CITY OF FORT LAUDERDALE

# DEVELOPMENT REVIEW COMMITTEE

## CASE COMMENT REPORT

<b>CASE:</b>	UDP-S24011
<b>MEETING DATE:</b>	April 23, 2024
<b>REQUEST:</b>	Site Plan Level II Review: 288-Unit Multifamily Residential Development with an Associated Parking Reduction Request
<b>APPLICANT:</b>	Miller Property Investment, LLC. And Bellissima Real Estate, LLC.
<b>AGENT:</b>	Josh Bailey, FSMY Architects & Planners
<b>PROJECT NAME:</b>	100 NW 7th Avenue
<b>PROPERTY ADDRESS:</b>	100 NW 7th Avenue
<b>ZONING DISTRICT:</b>	Regional Activity Center - West Mixed Use District (RAC-WMU)
<b>LAND USE:</b>	Downtown Regional Activity Center
<b>COMMISSION DISTRICT:</b>	2 – Steven Glassman
<b>NEIGHBORHOOD ASSOCIATION:</b>	Progresso Village Civic Association
<b>CASE PLANNER:</b>	Adam Schnell

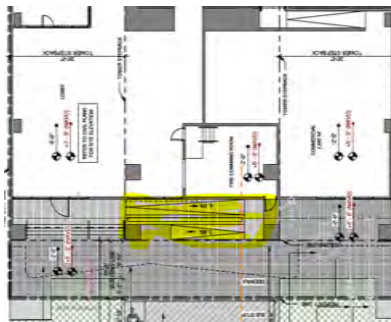
r. SF4 – Does not meet intent. The floor height along NW 7th Avenue is less than 15 feet tall; moreover based on the height of the structure, a the height of the first floor should be increased in proportion to height of the building.

s. SF6 – Reduce depth of shading devices. Shading devices not permitted within the right-of-way.

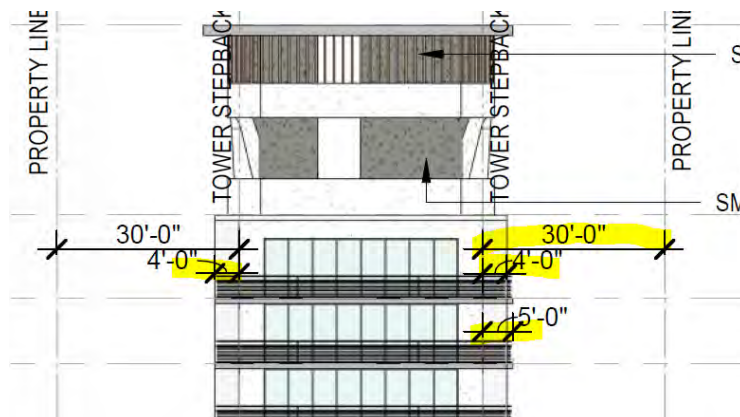
a. Properly delineate overhangs on the site plan along both east and west elevations and remove any overhang encroachments into the right-of-way.

b. Relocate and realign the ramp to a less prominent location, so it does not run along the frontage. Consider internalizing the ramp to decrease the presence of the ramp along 7<sup>th</sup> Avenue.

c. Relocate the fire command room and integrate activated first floor space.

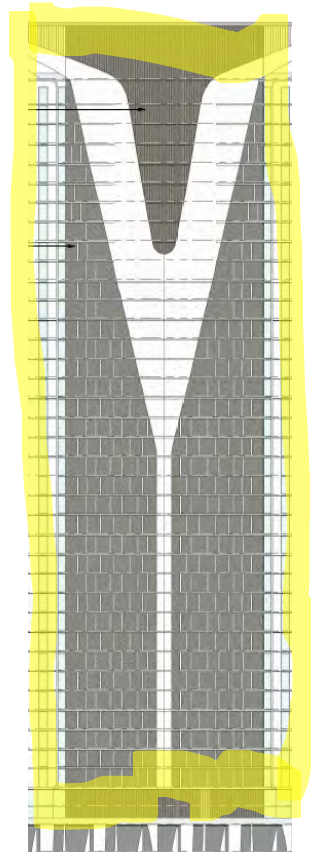
- a. Tower separation is measured from face of balcony and not the face of buildings. The current design has the balconies on the northern and southern facades encroaching into the required 30-foot tower separation area. If balconies encroach into the tower separation area, approval is required by the City Commission via a design deviation request.
